**MANASQUAN PLANNING BOARD MEETING AGENDA
CONDUCTED WITH ZOOM
JULY 05, 2022 7:00 PM – TUESDAY**

Re: Boro File No. MSPB-R1480
Variance – Tackett
Block 165, Lot 30
75 Beachfront
R-4 Single-Family Residential Zone
Borough of Manasquan, Monmouth County, NJ

Re: Boro File No. MSPB-R1870
Use Variance/Major Subdivision/Site Plan – Ocean Bay Developers LLC
Block 23, Lots 7.02 & 10
39 South Street
B-1 - Business Zone
Borough of Manasquan, Monmouth County, NJ

DRAINAGE EXHIBIT FOR:
BLOCK 23, LOTS 7.02 & 10
 BOROUGH OF MANASQUAN
 MONMOUTH COUNTY, NEW JERSEY

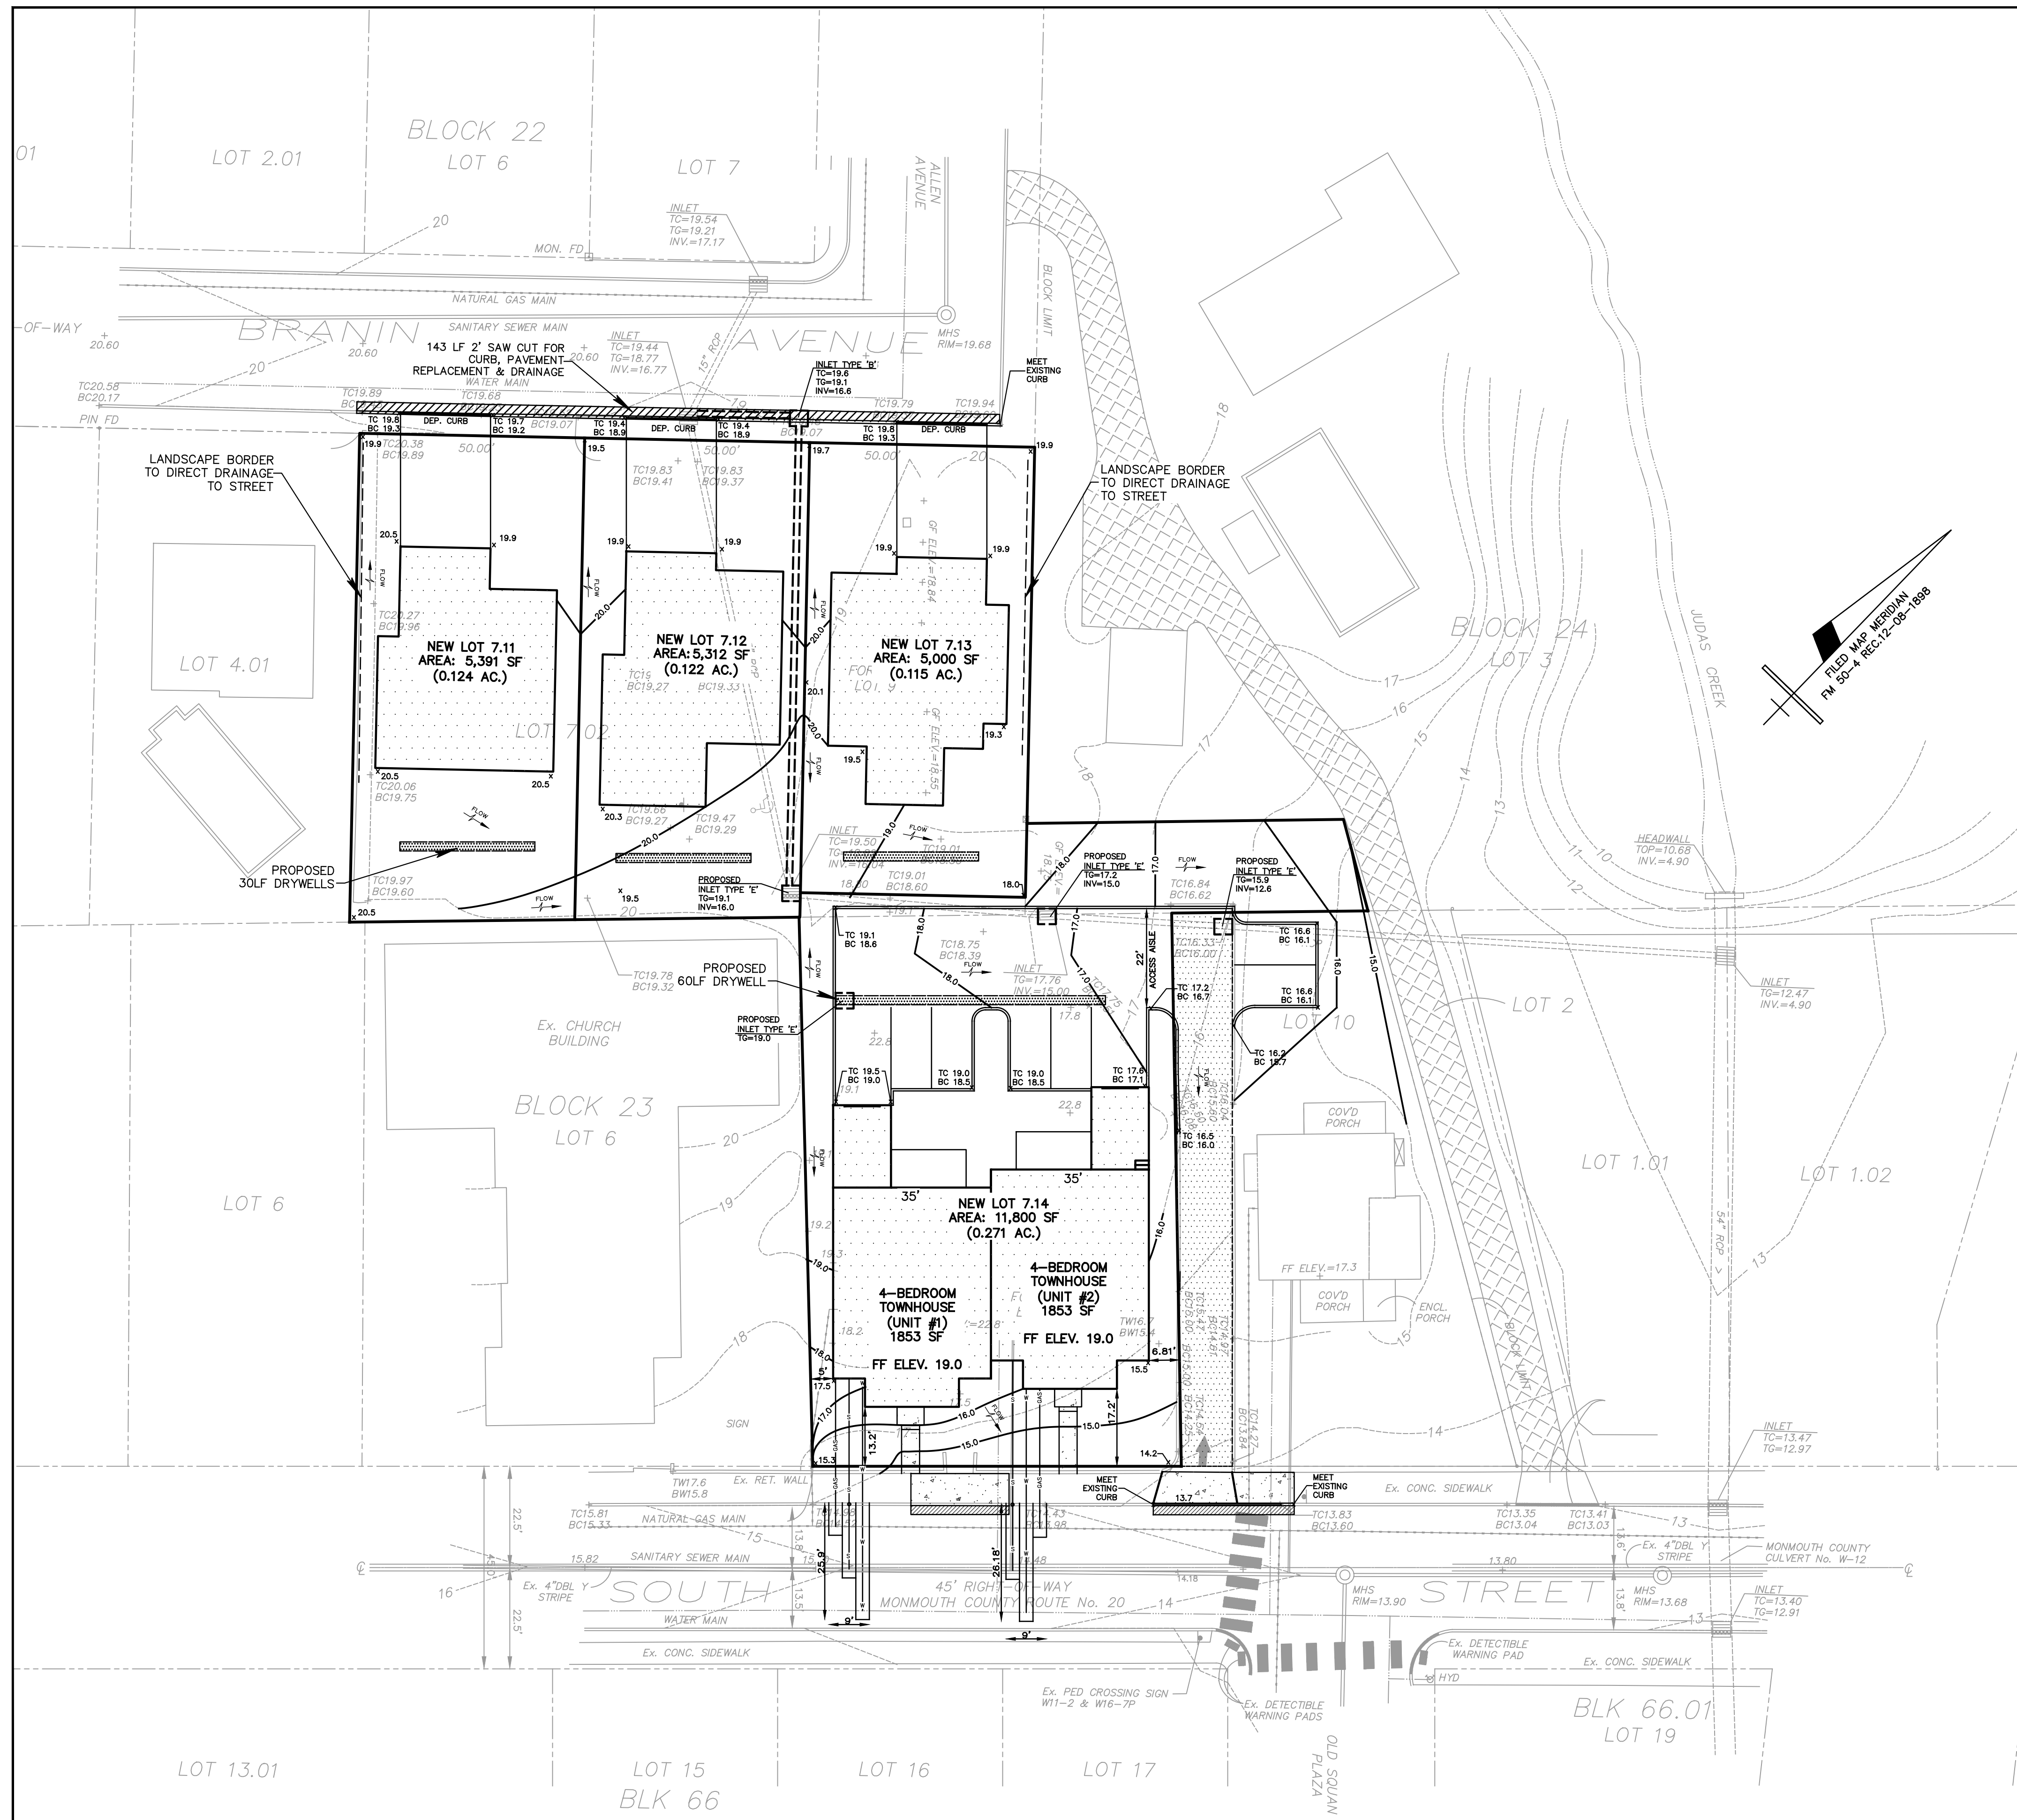
11. The application proposes to relocate the existing Borough drainage line located within an existing easement on the subject property and add a drainage inlet on Branin Avenue within the Borough right-of-way. Although the drainage layout appears acceptable, approval from the Borough Council will be required to vacate the existing easement, create the new easement and install the new drainage improvements. The extent of roadway repair to install the new drainage must also be shown on the plan and all necessary construction details provided.

12. Grading plans and offsite elevations for the three proposed residential lots must be shown to demonstrate there will be no adverse stormwater impacts to the surrounding properties.
